FHWA REGION NO.	STATE	PROJECT NO.	YEAR	SHEET NO.	TOTAL SHEETS
7	KANSAS	54-87 K-6657-01	2002	130	1122

RECORD DRAWING

CITY OF WICHITA			
PAVING BRICK & MEDIAN NOSE DETAILS			
SEDGWICK COUNTY			
Professional Engineering Consultants, P.A. 303 S. TOPEKA • WICHITA, KANSAS 67202 316-262-2691 • FAX 316-262-3003			
Designed by	WDH	Checked by	WDH
Drawn by	JGP	Date	April, 2002
		Job No.	97362

PAVING BRICK (MEDIAN) & (PARKING)

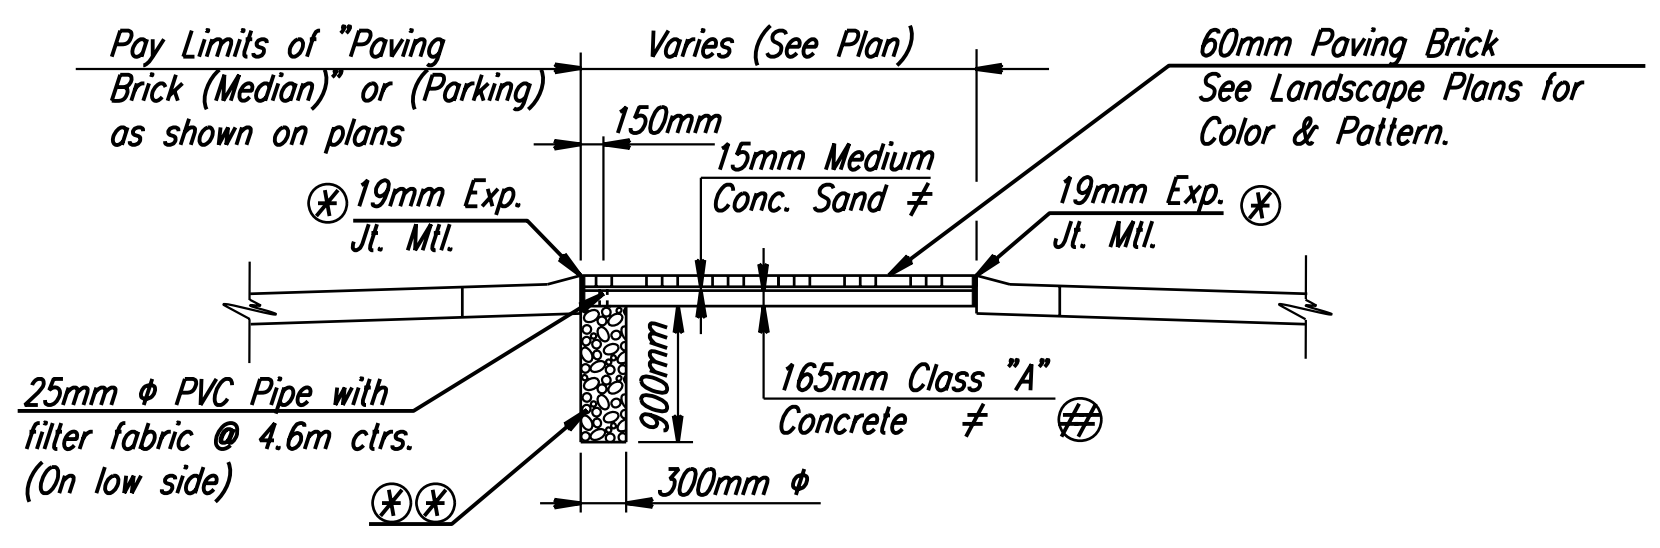
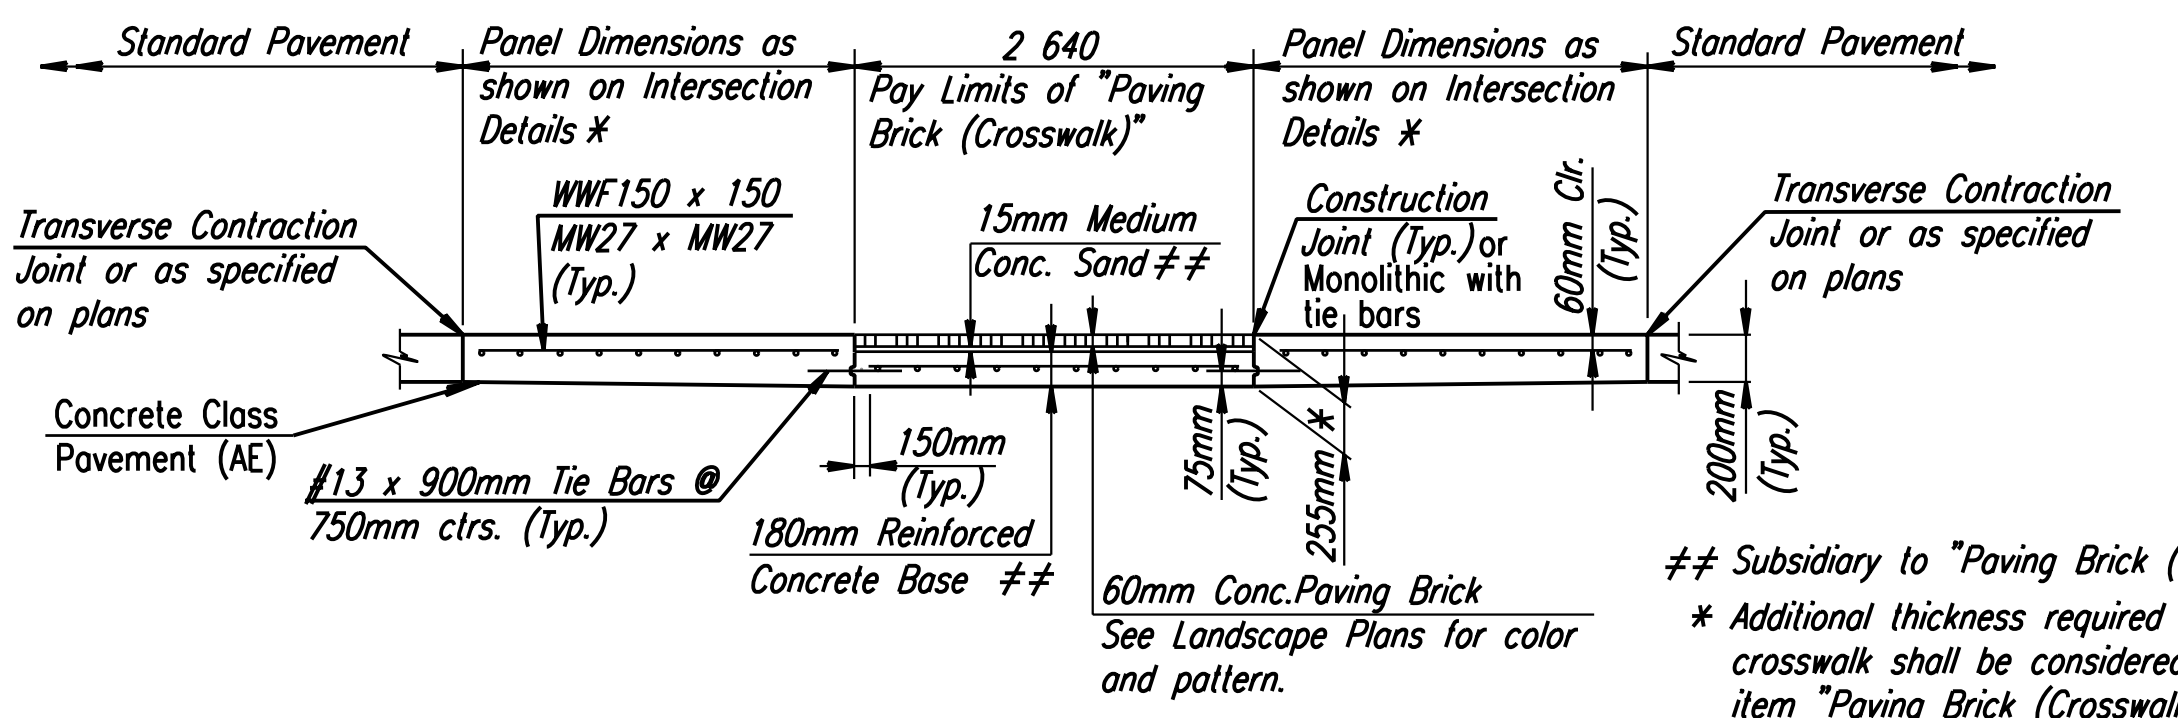
Paving Brick (Parking)  
 ⊕ Substitute AB-1 base material where specified as Paving Brick (Parking). Delete 25mm weepholes and underdrain holes. Provide Expansion Joint material between pavers & curb. Contractor substituted 3/4" concrete rock with filter fabric on top for AB-1.
